UNITED STATES  
NUCLEAR REGULATORY COMMISSION

SUBJECT: SUMMARY OF MEETING WITH DUKE COGEMA STONE & WEBSTER  
TO DISCUSS TECHNICAL TOPICS ASSOCIATED WITH THE MIXED  
OXIDE FUEL FABRICATION FACILITY

On February 3, 2000, the U.S. Nuclear Regulatory Commission (NRC) staff met with representatives from Duke Cogema Stone & Webster (DCS) to discuss technical topics associated with the mixed oxide (MOX) fuel fabrication facility. Topics discussed include worker dose, HVAC/confinement, use of polycarbonate materials for glovebox windows, fire protection, and controlled area boundary. The attendance list, meeting agenda and slides used in the presentation are attached (Attachments 1, 2 and 3, respectively).

### **Meeting with Duke Cogema Stone&Webster (DCS) to Discuss Technical Issues Associated with the Mixed Oxide (MOX) Fuel Fabrication Facility**

## Confinement During/After Seismic Event

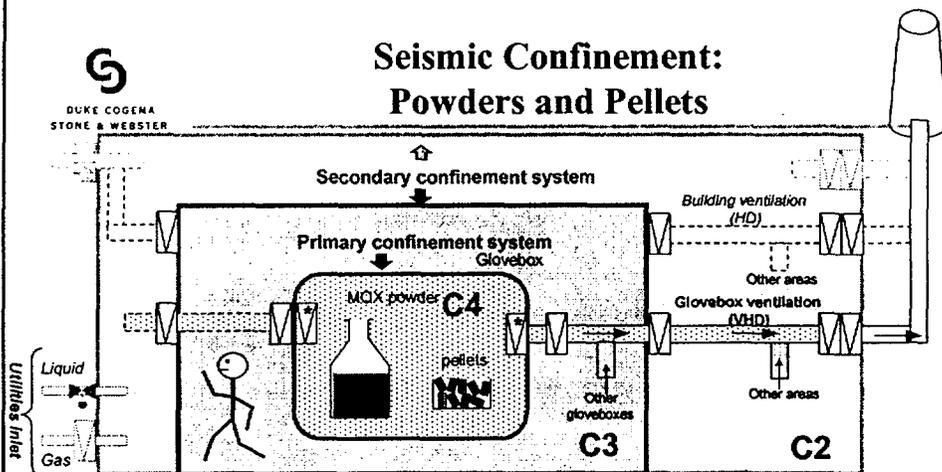
During the presentations, in response to NRC staff questions, DCS indicated that: 1) regarding the location of the worker with respect to potential accidents, the worker doses discussed by DCS would apply, in general, to the worker located at the potential breach of a glovebox; 2) the pressure differential between outside the building and the C1 confinement area is normally maintained at zero; 3) the positive value indicated on page 8 of the HVAC/confinement slide for the C1 confinement area normally occurs when the truck bay doors are opened; 4) DCS's use of the word "intact" on page 17 of the HVAC/confinement slide means that the confinement

systems are able to perform their functions; 5) whether DCS considers radiation monitors as "items relied on for safety" will depend on the results of the integrated safety analysis; and 6) a DCS design goal, with respect to fire protection, is to not designate fire protection systems as "items relied on for safety," as defined in the proposed Part 70 rule, but to assure that the fire protection systems are seismically restrained so that they do not interfere with items that are designated as "items relied on for safety"; to do this, risk from fire would have to be shown to be "highly unlikely."
